*Mewbourne Oil Company***Plug and Abandon**

Wellname: RESLER YATES STATE #353**Location:** 330' FNL & 2310' FEL, B-32-18S-28E- Eddy Co,
NM**Date:** August 7, 2025**API #:** 30-015-22141**Surf Csg Set:** 8 5/8" 28# J-55**Csg Size:** 4 1/2" 9.5# J-55**Set @:** 300'**Set @:** 2099'**Int:** N/A**Perfs:** 2022'-2038'**Set @:** _____

Action 524496

Operator: MEWBOURNE OIL CO P.O. Box 5270 Hobbs, NM 88241	OGRID: 14744
	Action Number: 524496
	Action Type: [C-103] NOI Plug & Abandon (C-103F)

RESLER YATES STATE #353 P&A Schematic

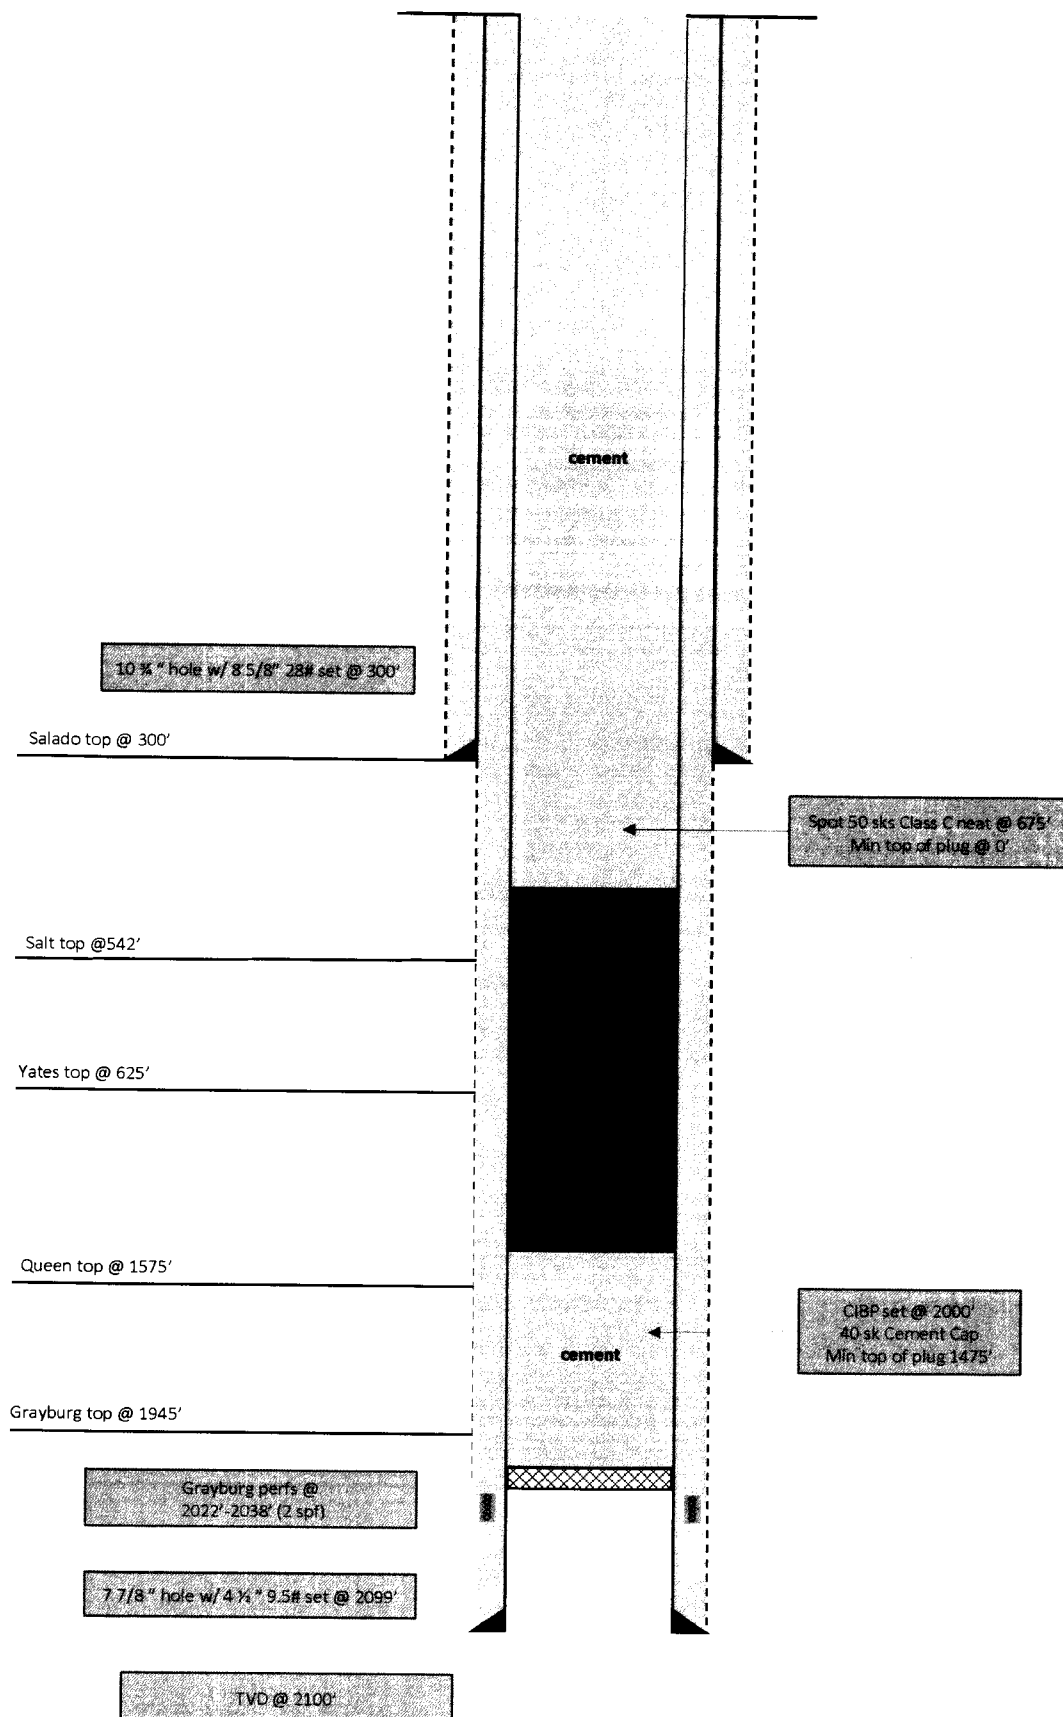
Created By	Condition	Condition Date
loren.diede	Notify the OCD inspection supervisor via email 24 hours prior to beginning Plug & Abandon (P&A) operations.	11/13/2025
loren.diede	NMOCD does not consider this well to be within the LPCH restricted area and an above ground P&A marker is required. NMOCD requires that plug(s) be added to cover the 7 Rivers = (996').formation top. Submit photo and GPS coordinates of the P&A marker with the final P&A reports. The API# on the marker is to be clearly legible. Run CBL from CIBP to surface. Submit the CBL tif file to NMOCD for uploading into the Well Log File.	11/13/2025
